REGIONAL REVIEW NOTIFICATION

TO: Chairwoman Nicole Love Hendrickson, Gwinnett County Commission
ATTN TO: Catherine Long, Long Range Planning Manager, Gwinnett County
RE: Development of Regional Impact (DRI) Review
FROM: Mike Alexander, Director, ARC Center for Livable Communities

Name of Proposal: Mixed Use Development at Satellite Boulevard DRI 3650

Stream Buffers

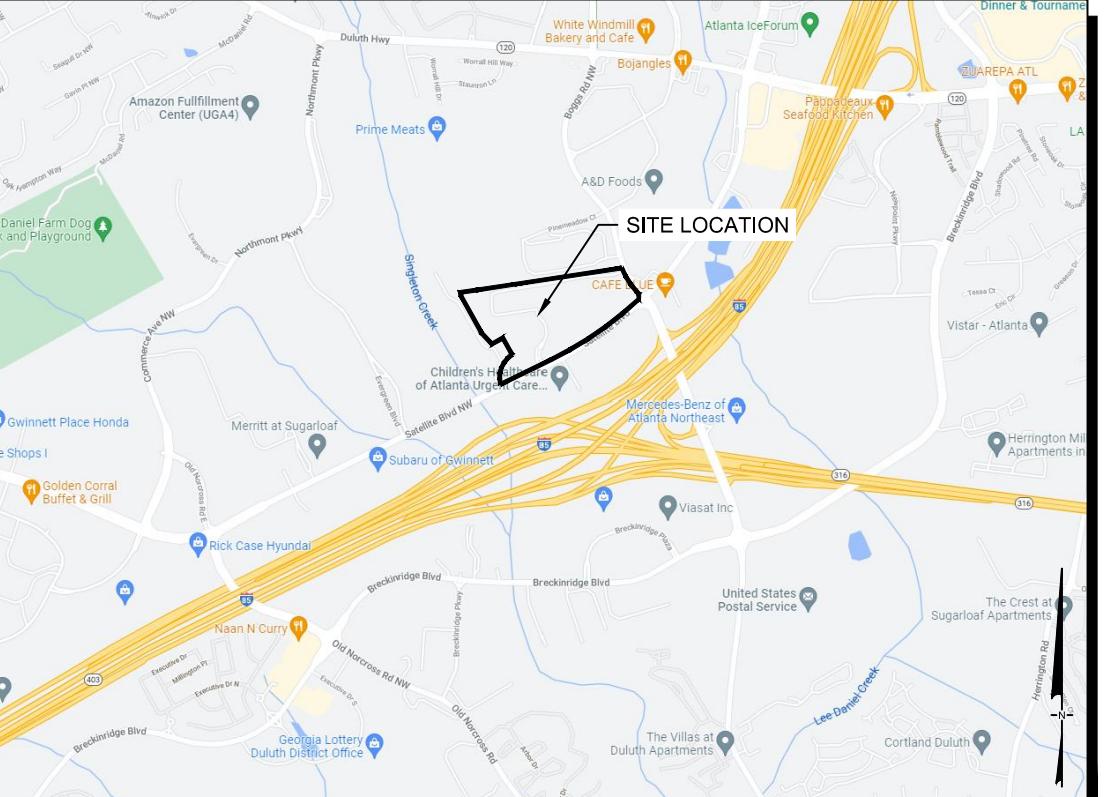
One USGS coverage for the project area shows an unnamed intermittent stream running from northeast to southwest across the project property. A second USGS coverage shows no streams on the property. Based on aerial photos, it appears that most of the stream was put underground when the existing development on the property was built. Only the southwestern portion of the stream remains visible. The site plan shows the County 50-foot stream buffer and 75-foot impervious setback along the visible portion of the stream, with a break where an existing detention pond dam crosses the stream. The State 25-foot Sediment and Erosion Control buffer is not shown on the plans. An access road crosses the stream at the edge of the property and a portion of a parking area is shown extending into a portion of the 75-foot County buffer. The parking area, as well as any other proposed intrusions into the buffers, may require a variance from the County. The State 25-foot Sediment and Erosion Control buffer needs to be shown. Any unmapped streams on the property may be subject to the County and State buffers. Any unmapped waters of the state will also be subject to the State 25-foot Sediment and Erosion Control buffer.

GRTA SITE PLAN

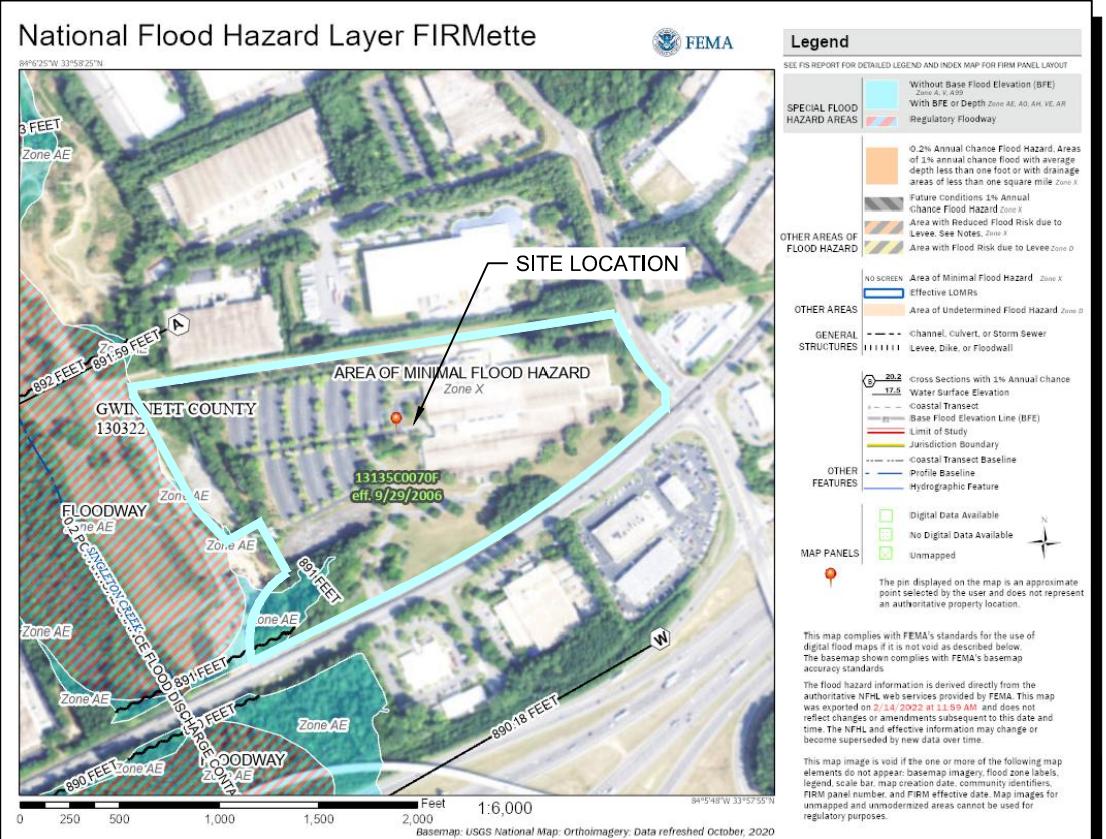
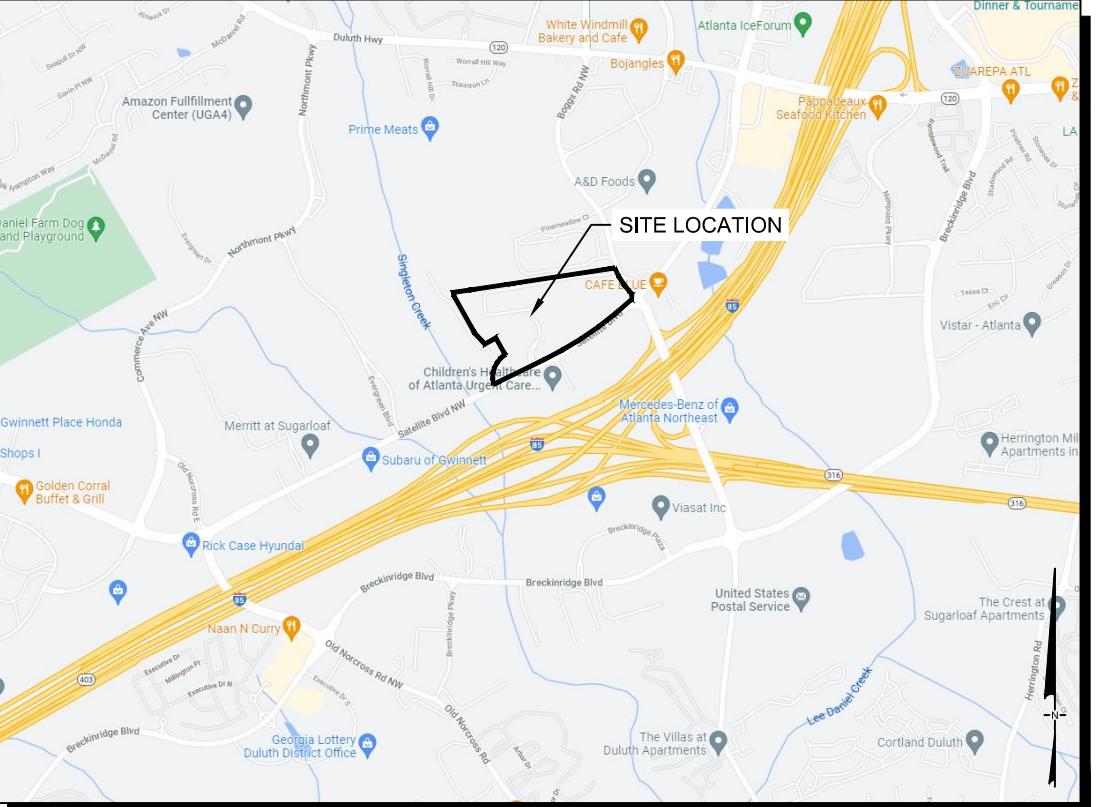
The project includes approximately 712 multi-family residential units along with 25,000 SF of retail and commercial uses. Adjustment of the layout of the southeastern section with the commercial area to achieve more building street frontage at the important corner of Boggs Road and Satellite Boulevard while maintaining parking visible from the street would enhance regional placemaking goals.

Some further adjustment of the overall layout to provide more direct access from buildings to the two proposed pocket parks and central common area would help increase park usage by residents. The central stormwater pond offers the ability to serve as more of a community central focal point rather than simply a functional stormwater system element. Provision of some common courtyard or green space area adjacent to the anticipated restaurant and retail space would enhance those uses as well.

The proposed 12-foot multi-use trail around the project is very supportive of regional policies promoting safe dedicated routes for both recreational and transportation related pedestrian and bicycle trips. Ideally the trail design will be aligned with any planned or future external trail connections. A potential alternate route of part of the Satellite Boulevard segment of the trail through the more central section of the project and partially fronting the commercial elements could provide a more inviting user experience as well as activation of food and beverage spaces.

The project includes the provision of space for a future BRT station along Satellite Boulevard. Adjusting the location of the stop towards the denser and more mixed-use southeast corner area may promote transit usage.

The site plan shows the County 50-foot stream buffer and 75-foot impervious setback along the visible portion of the stream, with a break where an existing detention pond dam crosses the stream. The State 25-foot Sediment and Erosion Control buffer is not shown on the plans. An access road crosses the stream at the edge of the property and a portion of a parking area is shown extending into a portion of the 75-foot County buffer. The parking area, as well as any other proposed intrusions into the buffers, may require a variance from the County. The State 25-foot Sediment and Erosion Control buffer needs to be shown. Any unmapped streams on the property may be subject to the County and State buffers. Any unmapped waters of the state will also be subject to the State 25-foot Sediment and Erosion Control buffer.

There is a substantial wooded area at the southwest corner of the project in between Driveway 1 and 2 where a stormwater pond is proposed; adjusting this pond to maximize tree retention would be further supportive of tree canopy and heat island reduction goals.
